**Additional Relevant Representation and Additional Comments/Queries Regarding ExQ1
Deadline 3 (02/07/2025)**

Additional Comments/Queries Regarding ExQ1

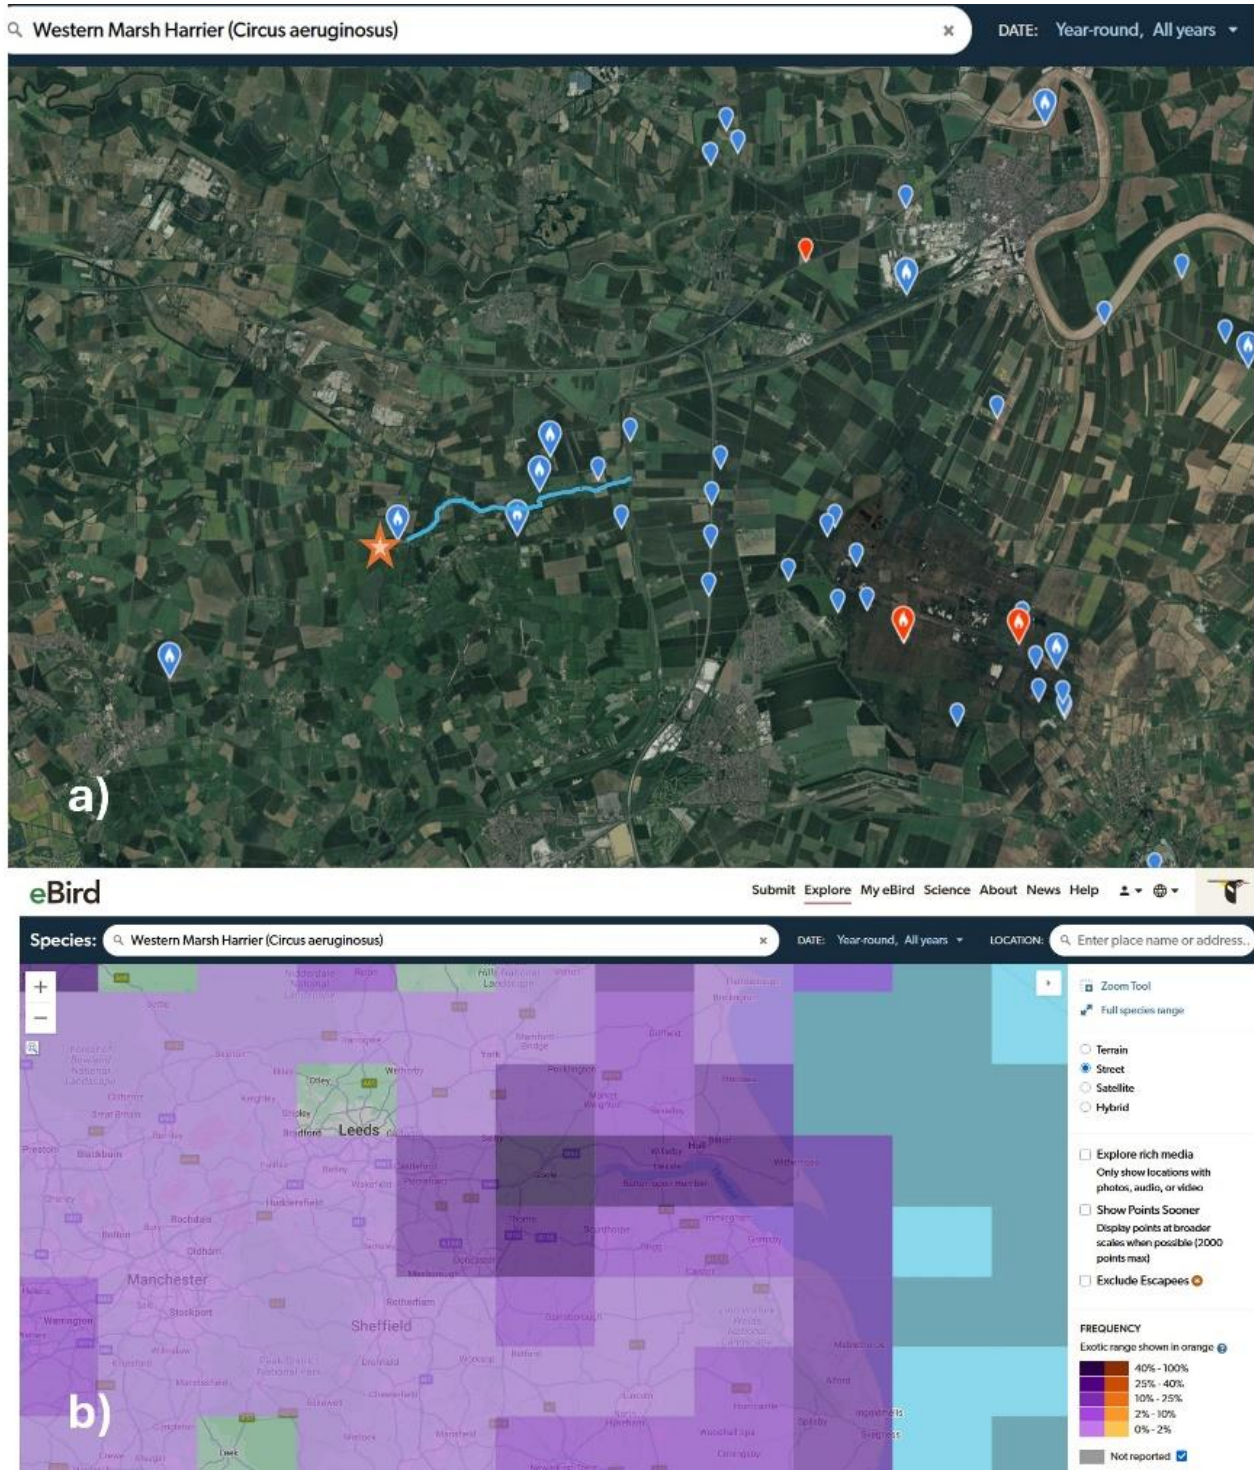
It is also the Trust's understanding that NE officers do not consider the candidate SSSI or the development area as functionally linked land due to their distance of 16km from the Humber Estuary. This contradicts the definition of Functionally Linked Land used in their study 'Identification of Functionally Linked Land supporting Special Protection Areas (SPAs) waterbirds in the Northwest of England' [Ref.NECR361], which states "*...areas of land occurring within 20 km of an SPA, that are regularly used by significant numbers of qualifying bird species. This definition has been developed and agreed with Natural England. A buffer of 20 km has been used based on the distance Pink-footed Geese tend to travel from their roost sites within an SPA site.*". It is worth noting the Pink-footed goose records submitted in previous relevant representations [REP1-054] and that Geese in the area are observed flying towards roost sites on Read's Island (Humber SPA) and Hatfield Moors (NNR / SAC) in the evening.

Similarly, for Western Marsh Harrier, radio telemetry studies demonstrate that both nesting and roosting birds will utilise habitat up to 15km away (Cardador and Mañosa, 2011), and at least 3 pairs nest on Thorne Moors SAC. These birds travel more widely in winter and are regularly recorded transiting East-West along the River Went corridor at Southfield Reservoir, and there are records of multiple birds within the DCO and over 50 observations at immediately adjacent areas at Topham. The spatial distribution of both local-scale observations (Fig. 1a) and region observation rates (Fig. 1b) demonstrates a very clear spatial link between birds occurring within the order limits of the DCO and those breeding and roosting on Thorne Moor SPA and more widely along the Humber Estuary.
